P.O.A.D.P. and P.U.D. PLAN
for

REDLAND RANCH SUBDIVISION

Re: Redland Ranch Unit 3 & 4

POADP # 498

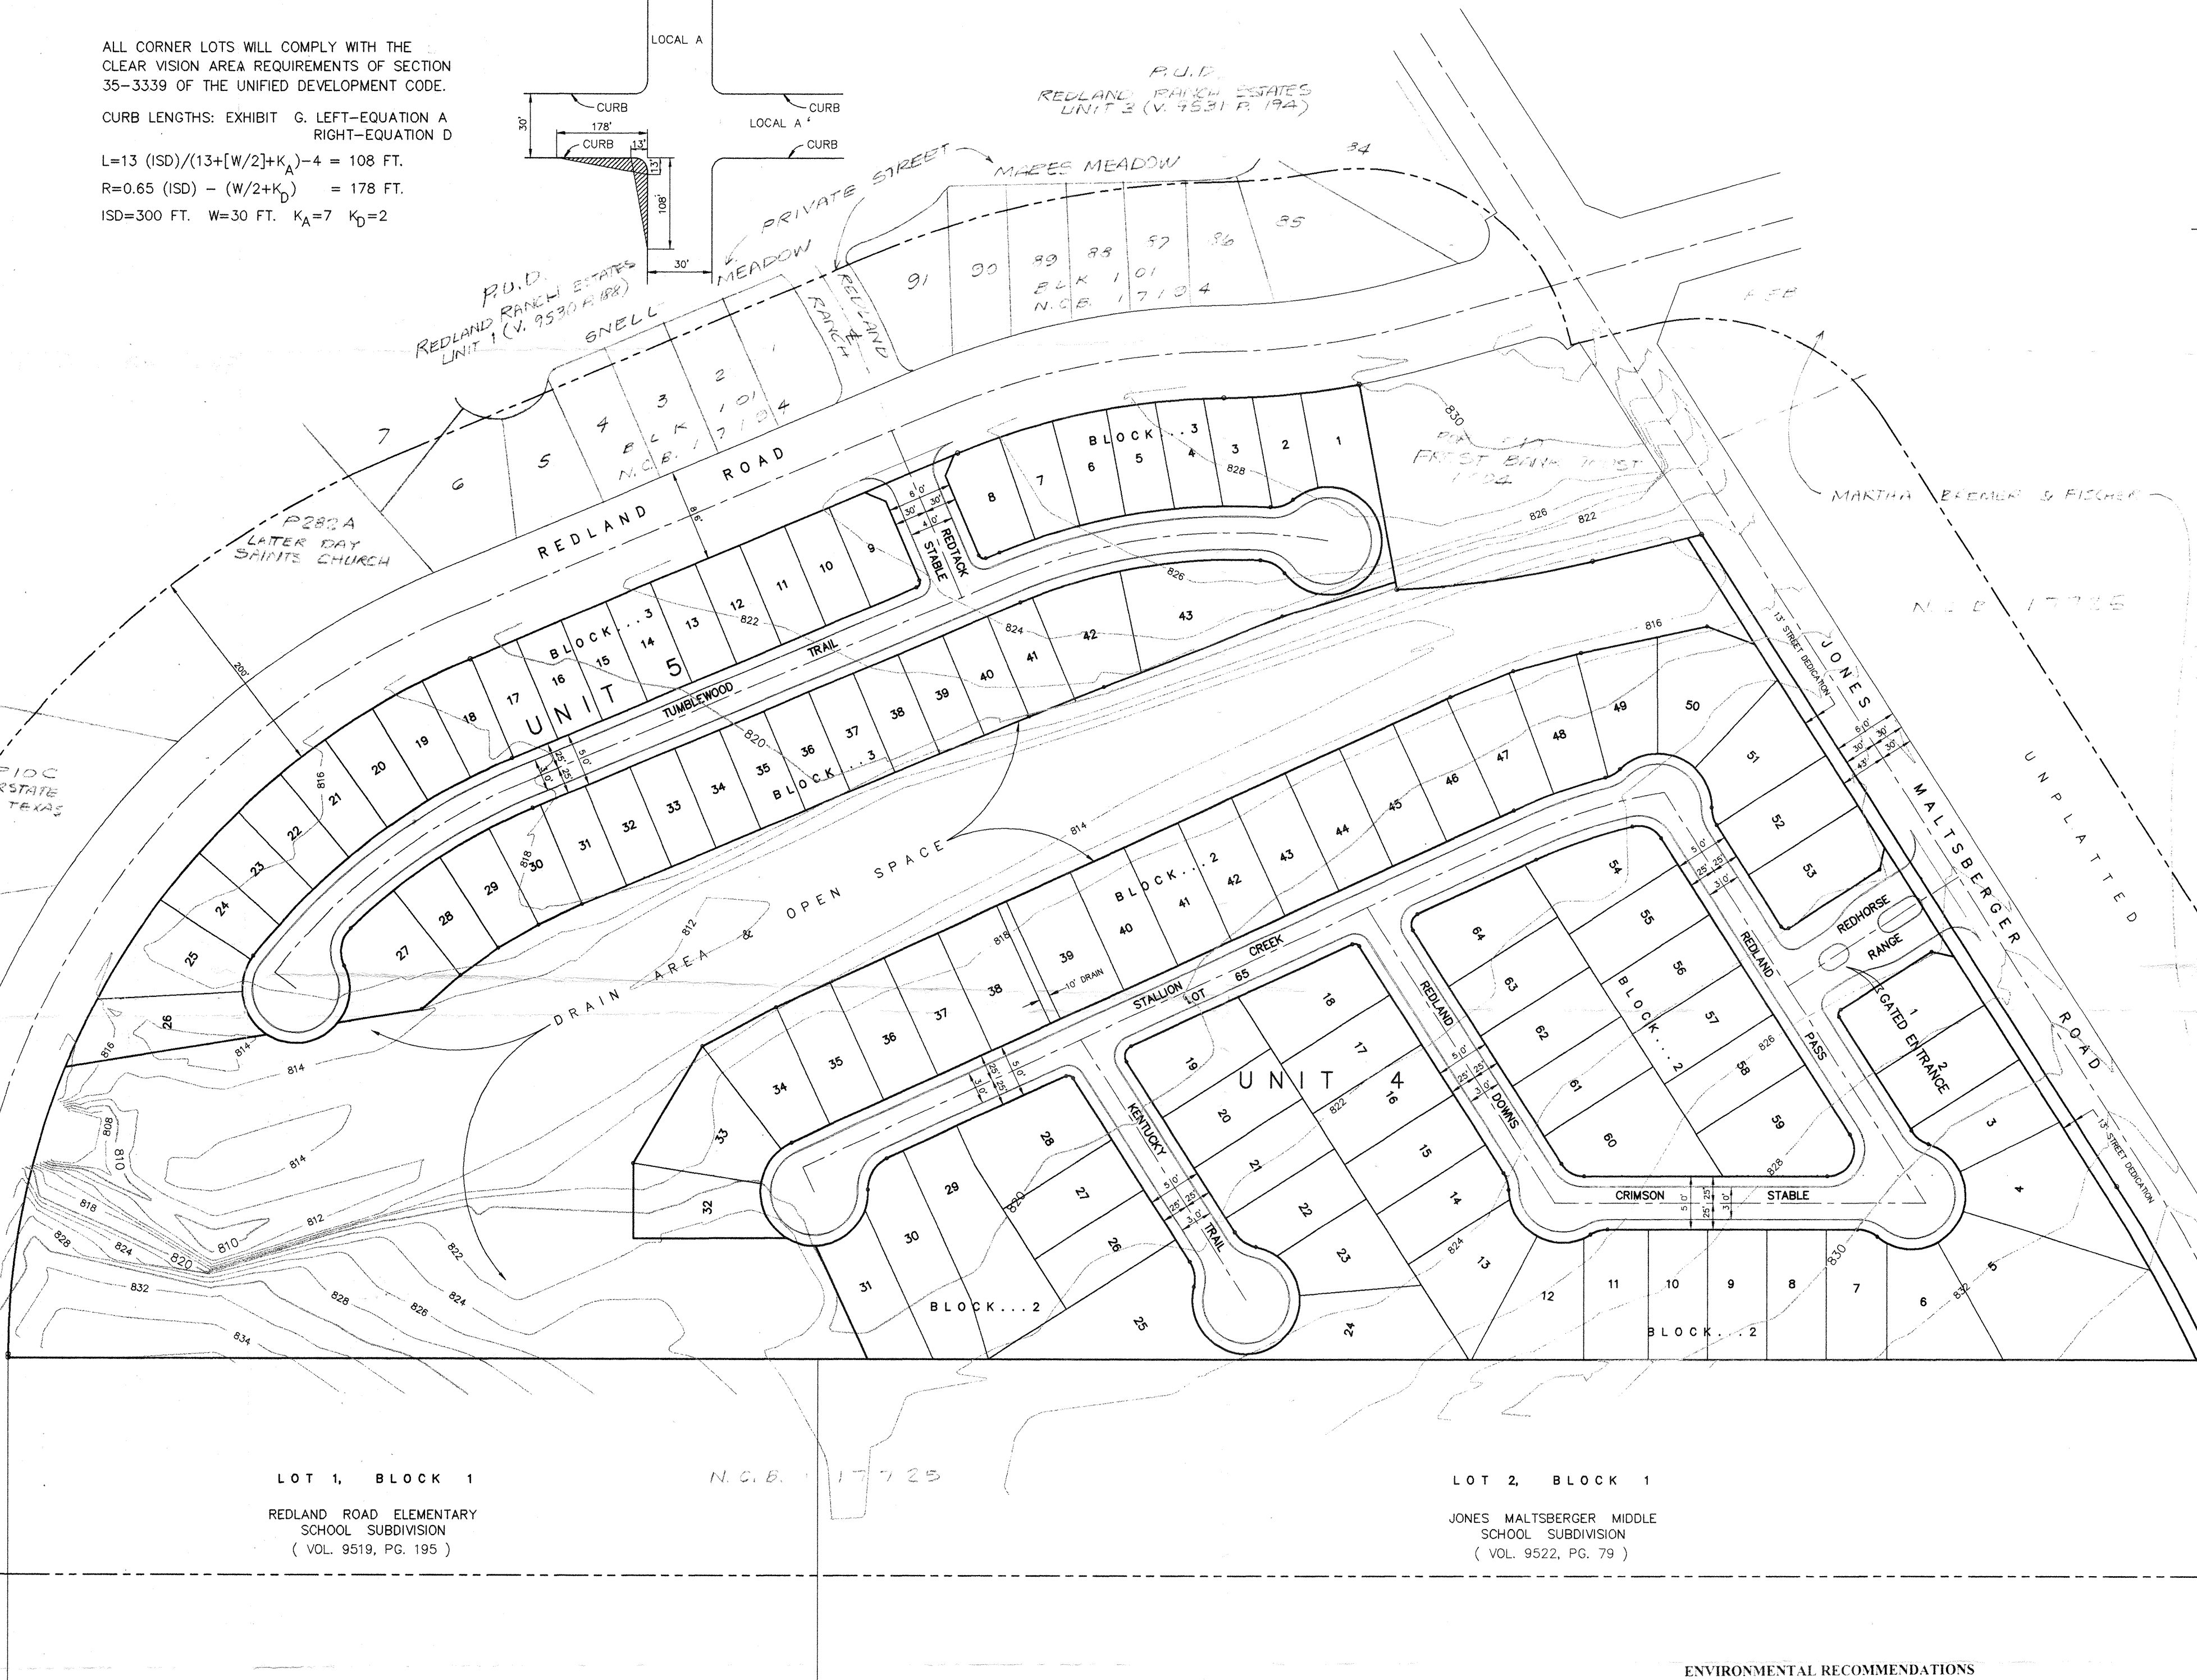
1. Based on the topography, a Flood Plain Study and drainage review will probably be required during the platting process.
2. A Gate Study be submitted to Amer Gilani, in Public Works.
3. This development will probably need to conform to requirements associated with development over the Edwards Aquifer. For additional information about these requirements you can contact SAWS at 704-7305.
4. We recommend that sidewalk and access be provided between lot 24 and lot 25 of unit 4; which will provide for pedestrian access to the Jones Maltsberger Middle School.

Comments: Drainage to be addressed
during the platting process.

A Flood Plain study will be
required during the platting process.
